APPEAL SUMMARY

Appeal ID: 20711	Project Address: 1650 SE Spokane St
Hearing Date: 8/7/19	Appellant Name: Brandon Yoder
Case No.: B-011	Appellant Phone: 5032523453
Appeal Type: Building	Plans Examiner/Inspector: Brian McCall
Project Type: commercial	Stories: 4 Occupancy: R-2 Construction Type: V-A
Building/Business Name: Spokane	Fire Sprinklers: Yes - Full NFPA 13
Appeal Involves: Reconsideration of appeal	LUR or Permit Application No.: 18-173206-CO
Plan Submitted Option: pdf [File 1]	Proposed use: Apartments

Appeal item 1

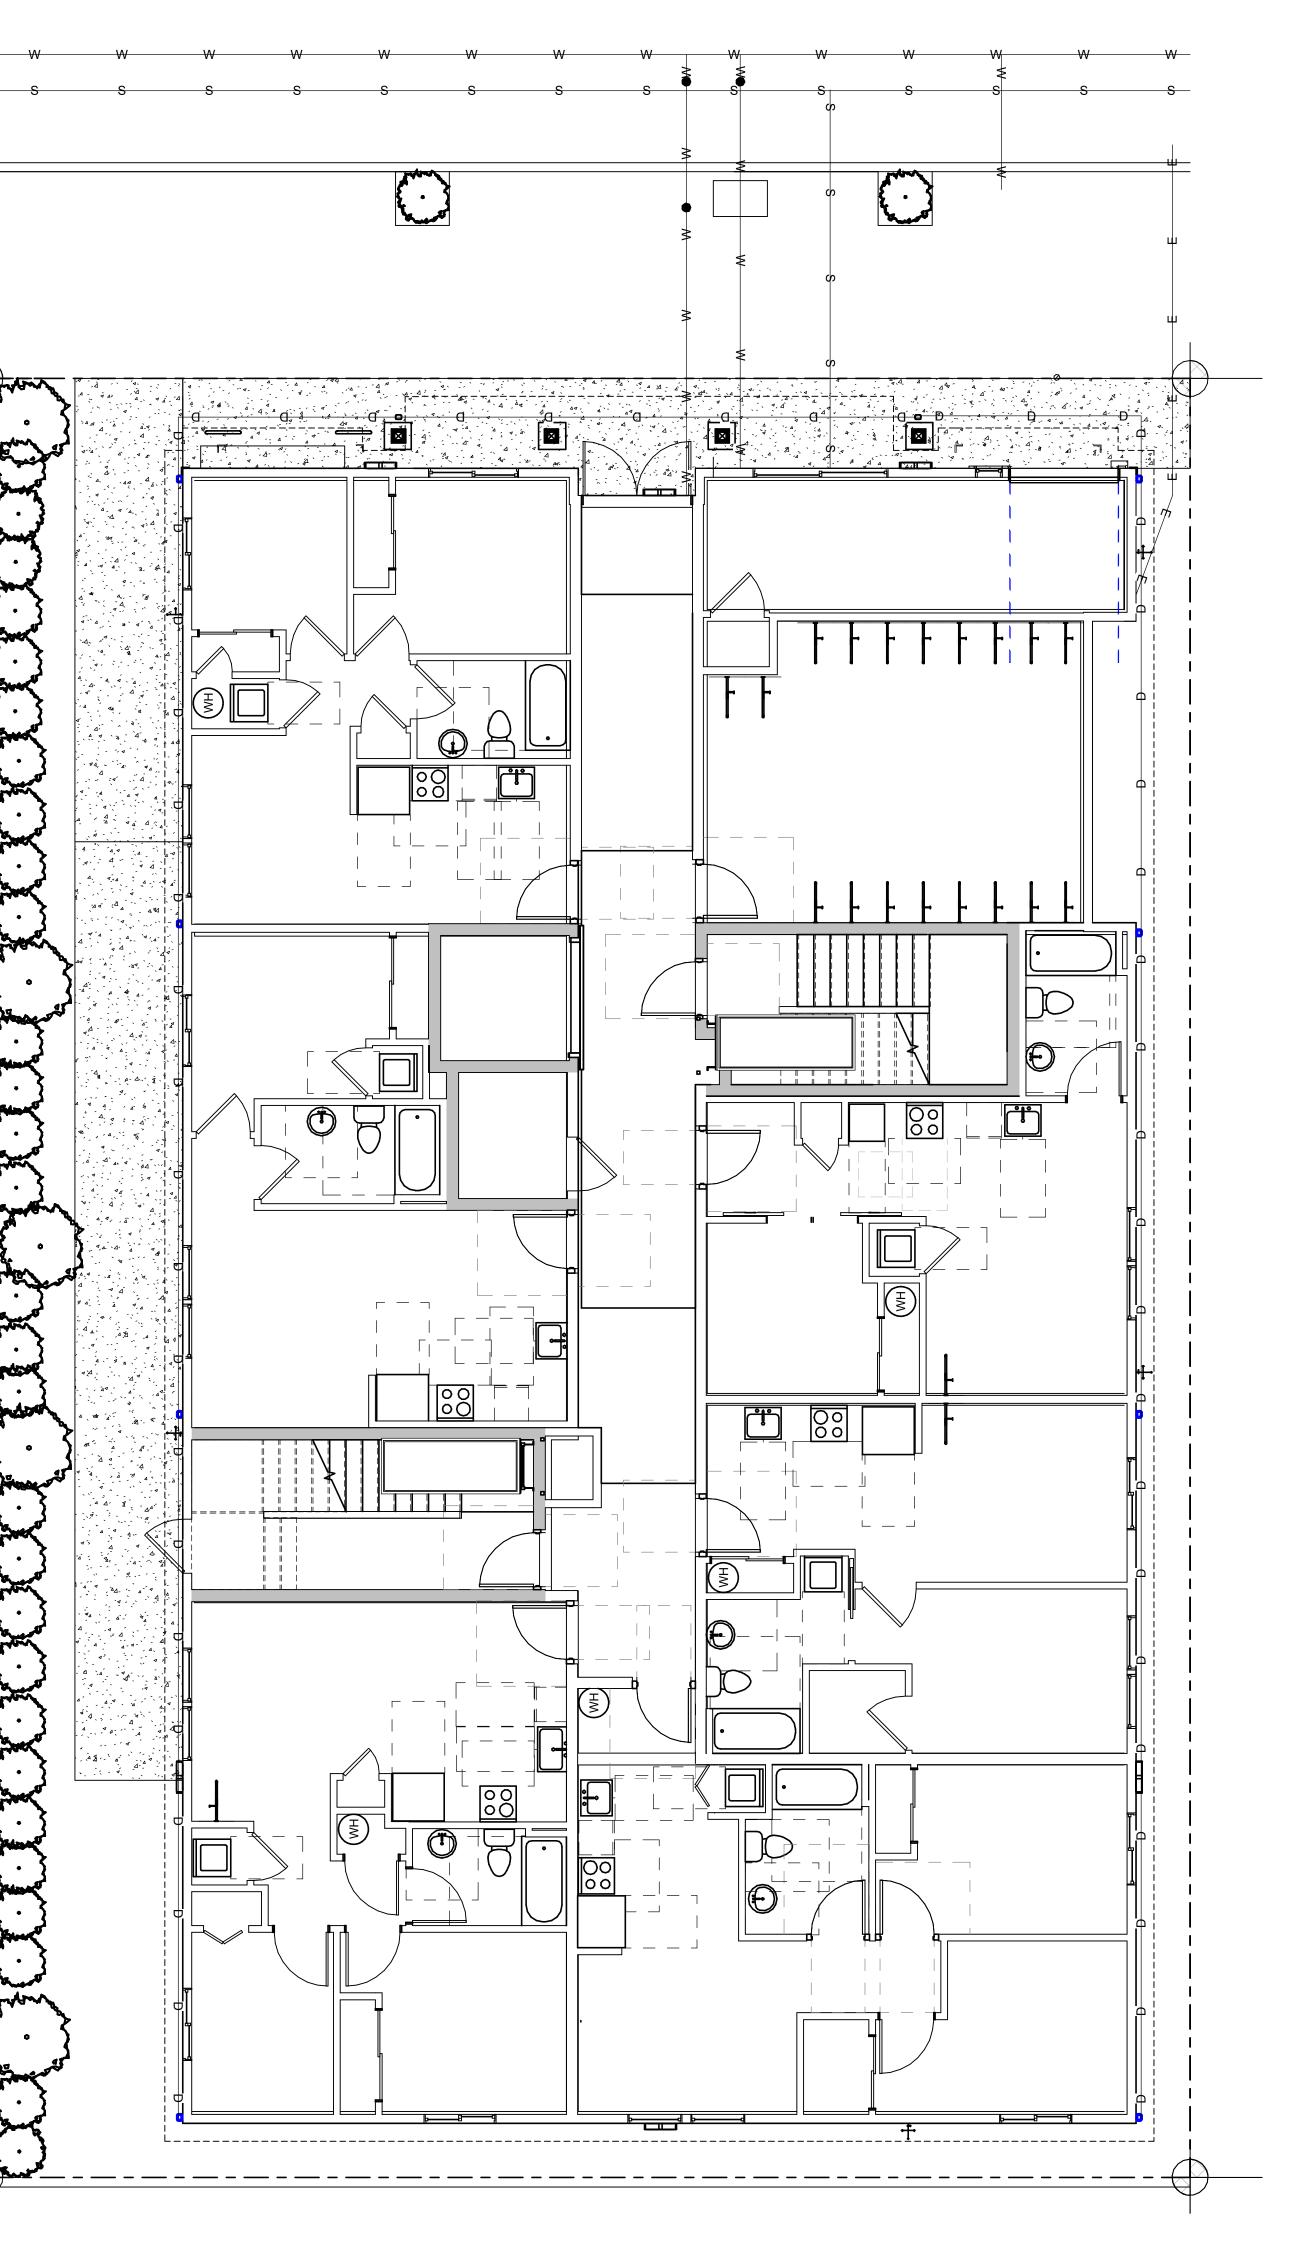
Code Section	705.8.6.2
Requires	705.8.6.2 Vertical Exposure for Buildings on separate lots
	When a new building is to be erected adjacent to an existing building, all openings in the exterior
	wall of the new building are required to be not less than 3?4 hour when these openings are less than
	15 feet vertically above the roof of the existing building or structure. The opening protections are
	required where the distance between the buildings or structures is less than 15 feet
Proposed Design	Proposed south wall of new building will be provided with window washer sprinkler heads, instead
	of 3?4 hour opening protective. Provide fire sprinklers at interior, installed between 4" (min) and
	24" (max)from windows, spaced at 6 feet on center max, sprinklers to be capable of wetting entire
	interior window surface. Entire building is sprinkled to the Full NFPA 13 system and is V-A construction.
Reason for alternative	The building is fully sprinkled to the full NFPA 13 system. All openings at this wall are compliant

with table 705.8, regarding allowable opening area relative to the entire wall area. Entire wall
	length is 1-hour fire rated. This new wall is adjacent to an existing wall on the adjacent property,
	the building on the adjacent lot is a type III-B concrete building with a parapet. The windows into
	the units at this area will provide much needed natural ventilation and light and are important to
	provide a healthy living environment.
	This proposed alternate has been approved by appeal for other comparable situations. Reference
	approved appeal 13298, Item 1.

Type 13 water curtain sprinkler protection at non-fire rated openings in buildings with vertical exposure on separate lots: Granted provided windows are non-operable and sprinklers are spaced not more than 6 feet apart and placed a minimum of 6 inches and a maximum of 12 inches from the opening(s) and a maximum of 12 inches below the ceiling. Sprinklers are to be installed on the occupied side of the openings.

A separate permit from the Fire Marshal's Office is required.

Note: This decision doesn't grant any mechanical openings.

TABLE 705.8 SOUTH ELEVATION - (3' SETBACK)

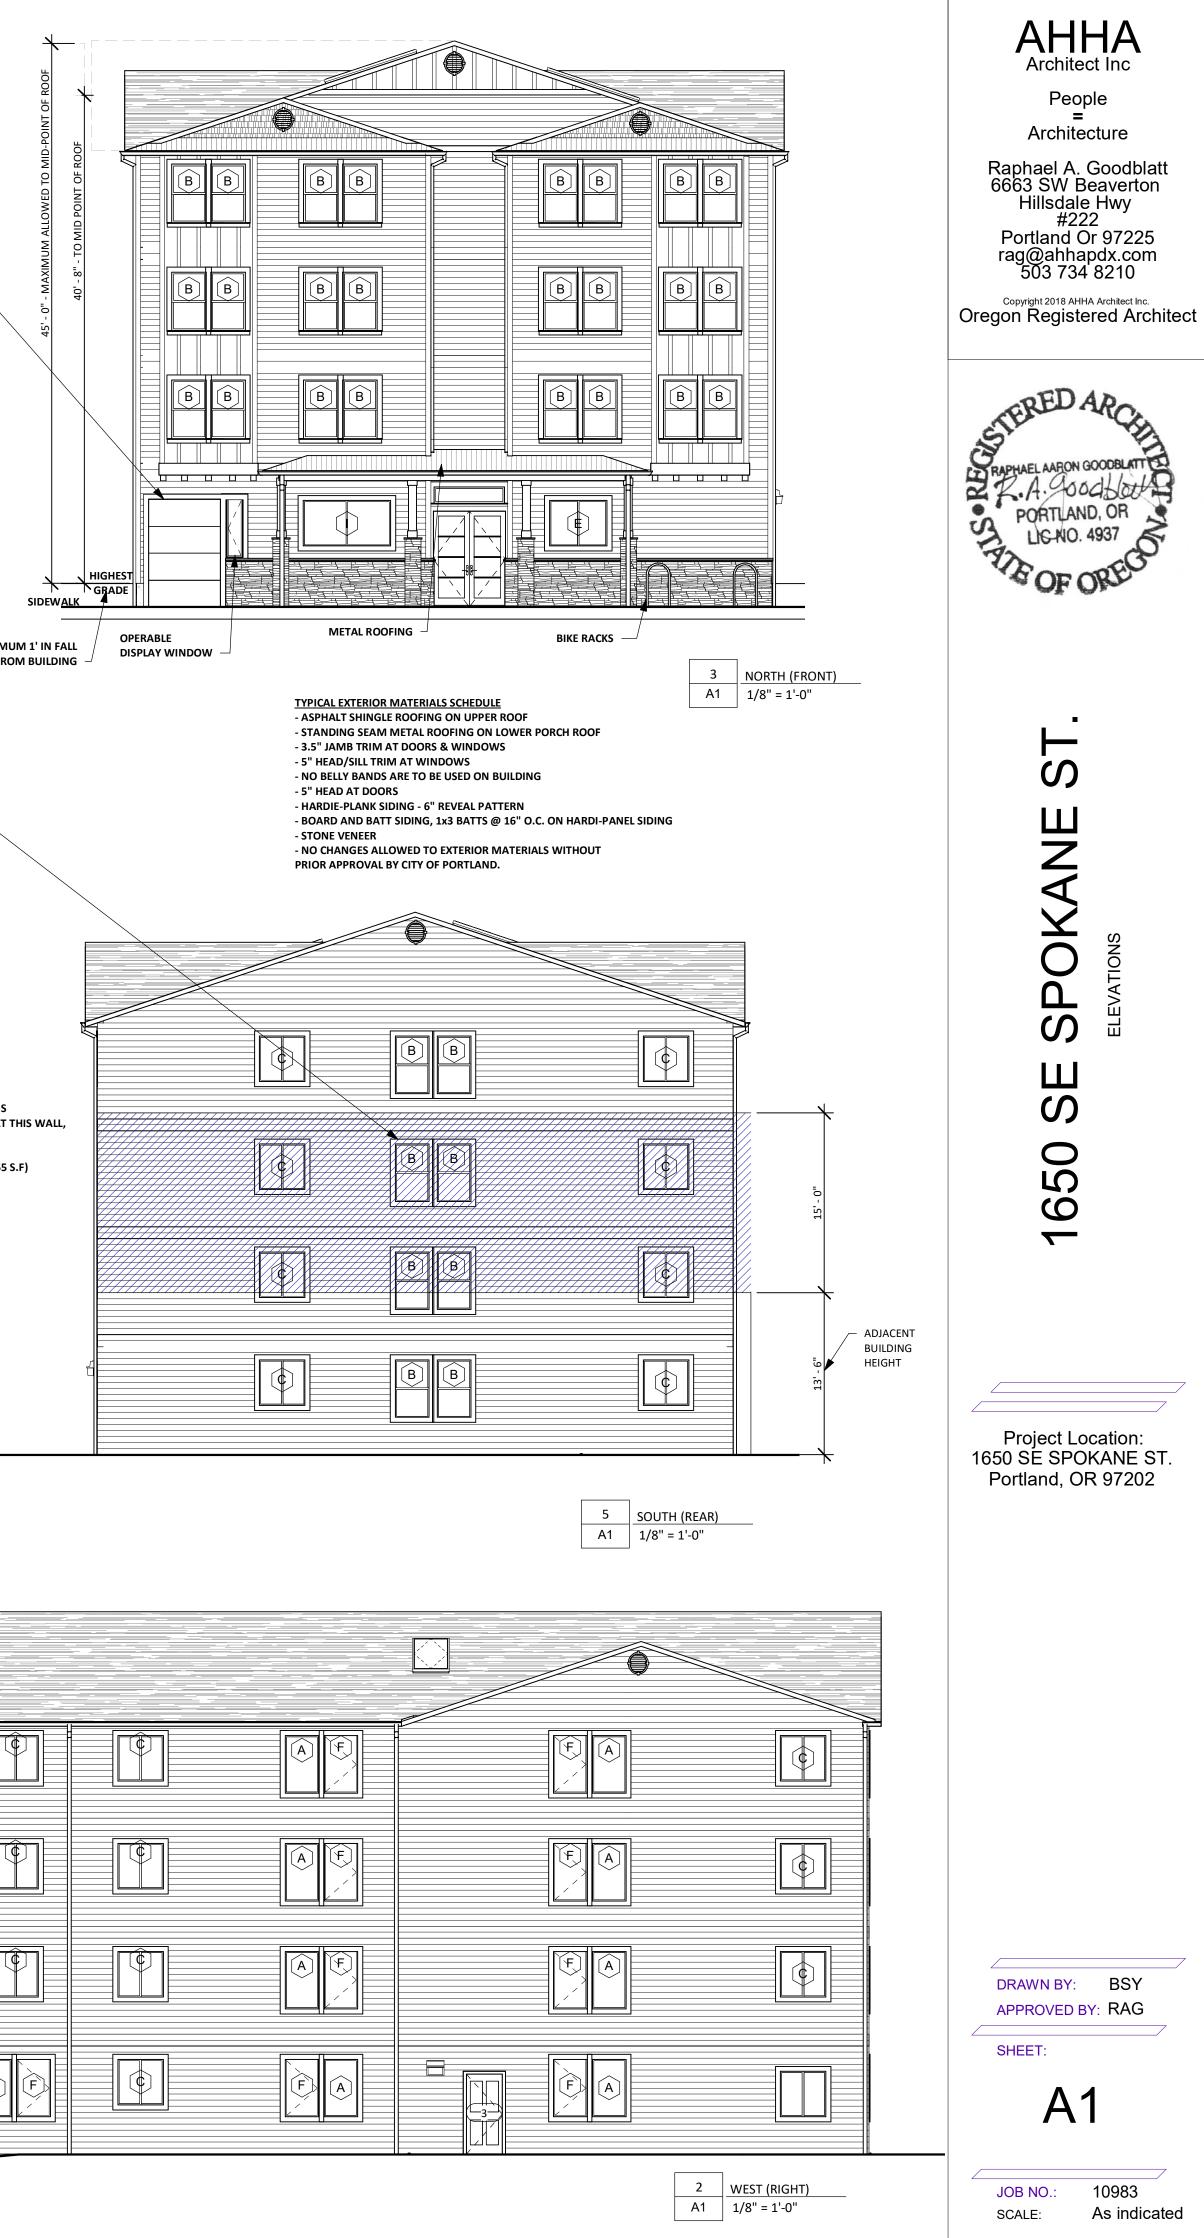
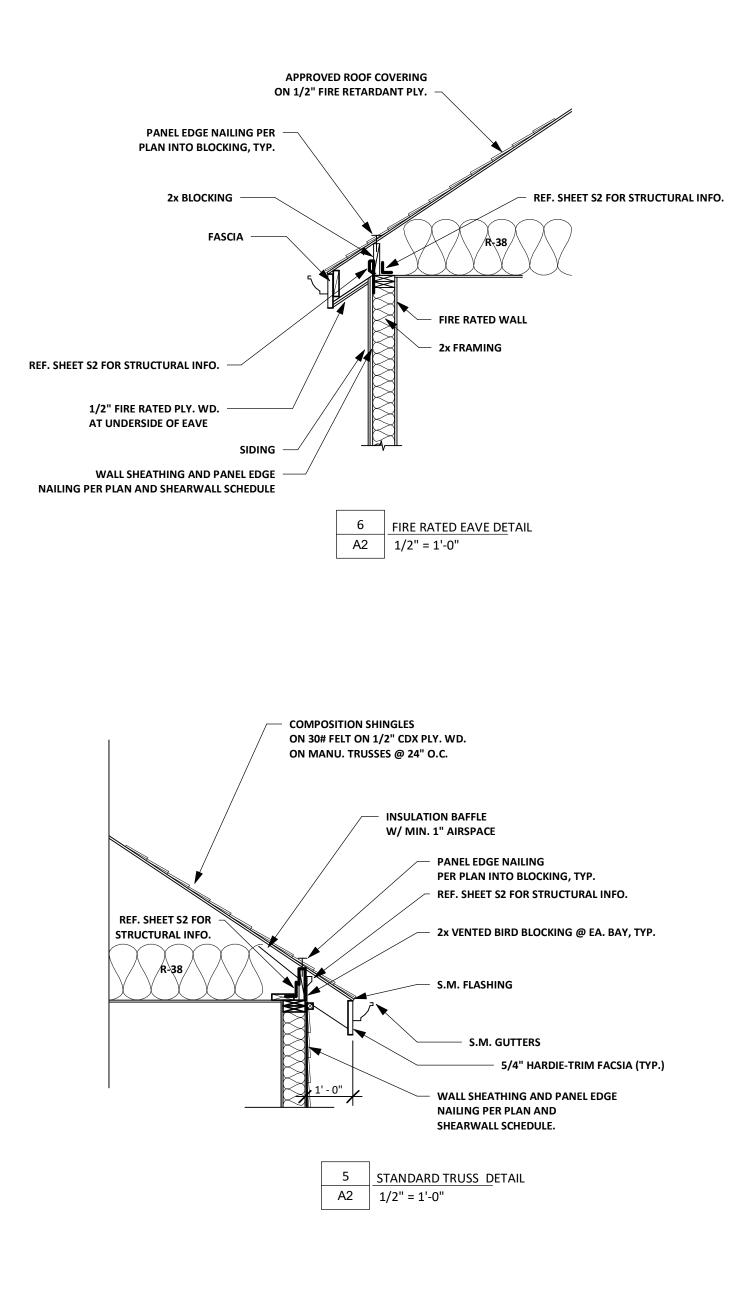
DUE TO PROXIMITY TO ADJACENT BUILDING ON ADJACENT LOT, HATCHED WINDOWS ALONG THE SOUTH ELEVATION SHALL **BE PROVIDED WITH WINDOW** WASHER SPRINKLER HEADS - PER SECTION 705.8.6.2 - VERTICAL EXPOSURE FOR BUILDINGS ON SEPARATE LOTS
